Access Compliance Report

Public Rights-of-Way

Intersection ID: 49801	Main Street: PARSIFAL_LN	Cross Street: GANDOLFO_CT	Location: S
ADA ID: ED654EF3C1B5	Ramp Type: Perp	Initial Pass/Fail: Fail	Overall Compliance: No
Codes/Mitigation Info/Possible Solution		Field Measurements/Component Compliance

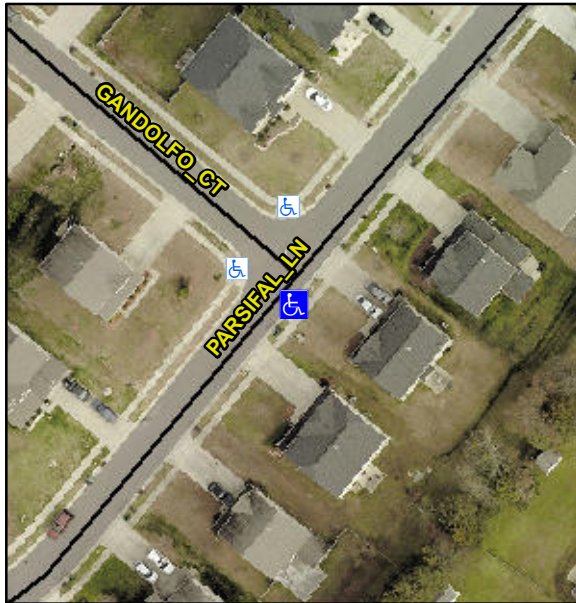
Not Found, R304.2.2, R304.5.3

Compliance	Description	Data	Compliance	Description	Data
N/A	Ramp Length (in)	58.0	No	Ramp Slope (%)	9.4
Yes	Ramp Width (in)	48.0	No	Ramp XSlope (%)	3.5
N/A	Flare Type LT	N/A	N/A	Flare Type RT	N/A
N/A	Flare Slope LT (%)	N/A	N/A	Flare Slope RT (%)	N/A
N/A	Flare Traversable LT?	N/A	N/A	Flare Traversable RT?	N/A
N/A	Landing Length (in)	N/A	N/A	DWS Provided?	N/A
N/A	Landing Width (in)	N/A	N/A	DWS Contrast?	N/A
N/A	Landing Slope (%)	N/A	N/A	DWS Length (in)	N/A
N/A	Landing X Slope (%)	N/A	N/A	DWS Full Width?	N/A
N/A	Landing Curb? (Y/N)	N/A	N/A	DWS Offset (in)	N/A
N/A	Shared Landing?	N/A			
N/A	Gutter Ponding?	N/A	N/A	Gutter Slope (%)	N/A
N/A	Gutter Lip Ht (in)	N/A	N/A	Gutter X Slope (%)	N/A
N/A	Painted X Walk1?	No	N/A	Painted X Walk2?	N/A
	X Walk 1 Direction	To NW		X Walk 2 Direction	N/A
N/A	X Walk 1 Width (in)	N/A	N/A	X Walk 2 Width (in)	N/A
	X Walk 1 Slope (%)	3.0		X Walk 2 Slope (%)	N/A
	X Walk 1 X Slope (%)	3.3		X Walk 2 X Slope (%)	N/A

Remove & Replace Entire Ramp.
